SYDNEY METRO CITY & SOUTH WEST
 CONSTRUCTION TRAFFIC MANAGEMENT PLAN
 VICTORIA CROSS SOUTHERN (VC2) SITE
 MAY 2017

This is a desktop traffic management plan road safety audit of the proposed Victoria Cross Southern Site traffic staging (Stage 2) as part of the Sydney Metro City & South West Project.

CTMP Review Comments Sheet

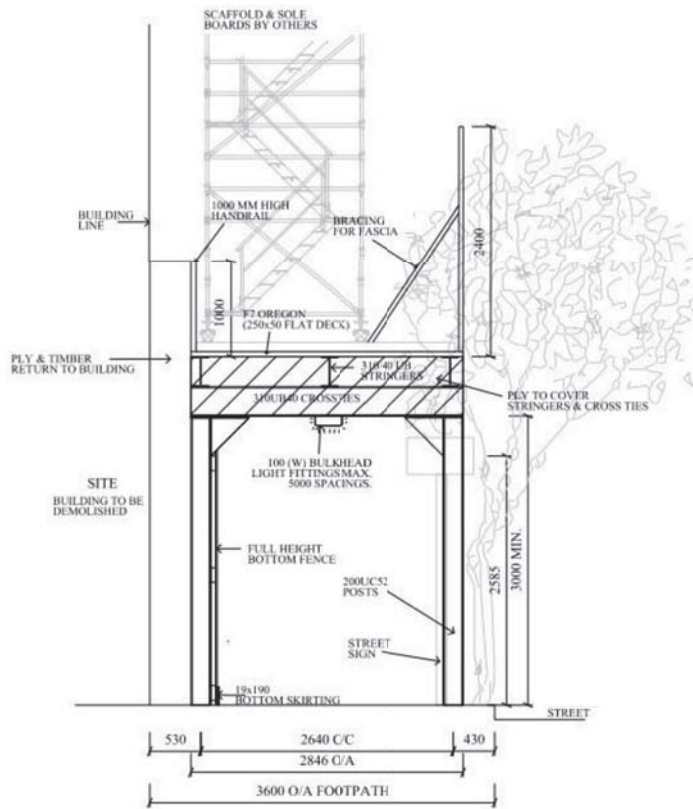
Item	Section/ Page	Comments	Response
6	2.2.5 & Appendix 2	The hoarding plan DD-SYD-DWG-0002-04 shows the B-Class hoarding extending out to the kerb line. This will affect all of Council's footpath which will make pedestrian access difficult and is considered excessive. Council also has a distribution box located within the proposed hoarding. Delta met with Council's Development Landscape Officer in February 2017 and it was indicated that the hoardings would be placed in line with the property boundaries. The hoarding in front of the jeweller building would be moved in-line with the other property lines once that building is demolished. This does not appear to be reflected in the Draft CTMP.	TfNSW and Delta have identified these areas as the main pedestrian thoroughfares that need protection.
7	2.2.5 & Appendix 2	Approval must be obtained from Council for all temporary construction hoardings. Application form is available on Council's website at https://www.northsydney.nsw.gov.au/Building_Development/Building_DA_Forms/Construction_Forms#4	Noted and document amended

DRAWING No:	DD-SYDM-DWG-0002-06
SHEET	1 OF 1
REVISION	C-00

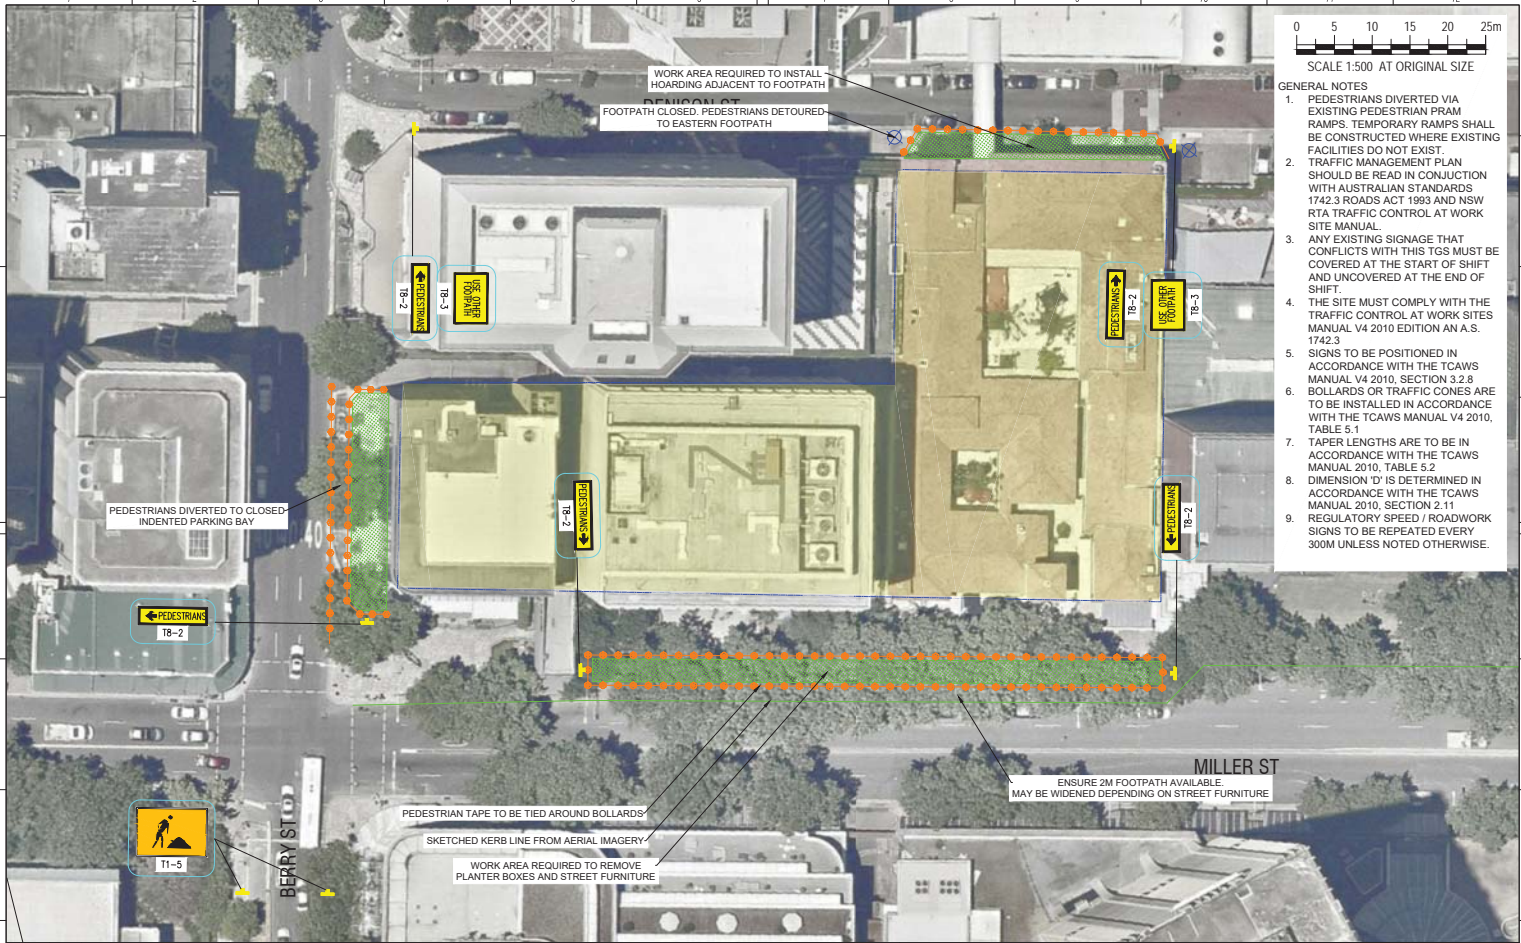
Item	Section/ Page	Comments	Response
1	2.2.5	Doesn't discuss any impacts to pedestrians on Berry Street. Is DD-SYDM-DWG-0002-06 a short term TCP?	Yes TCP 06 is short term – there will be minimal to no impacts to Berry Street pedestrian traffic.
2	DWG 0002-05	For what work types/ times is the proposal for a Miller Street lane closure planned	Refer to Appendix 3
3	DWG 0002-06	It is unclear when this TMP will be implemented. For individual shifts or weeks whilst the hoarding is installed? Appropriate pram ramps should be provided on either approach to enable pedestrians to access the indented parking bay on Berry Street It is unclear the intention of the flashing arrow sign on Berry Street. Is this to deter motorists from utilising this lane on Berry Street. If this is a longer term closure, has consideration been given to a more appropriate safety barrier for pedestrians than bollard as there is no kerb?	Refer to Appendix 3 – these are short term closures to allow awning removal/ installation of scaffolding and hoarding The flashing arrow unit was to highlight the closure – it is not a long term closure.

DRAWING No:	DD-SYDM-TYP-0000-02
SHEET	1 OF 1
REVISION	B-00

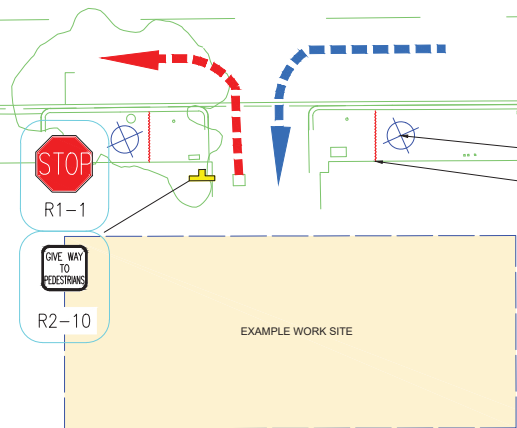
4	TYP- 0000-02	Consideration should be given to utilisation of pedestrian barriers during truck egress as well as entrance	Drawing amended
5		The hoarding and scaffold plans reference photos that aren't provided in the TMP	Drawing amended
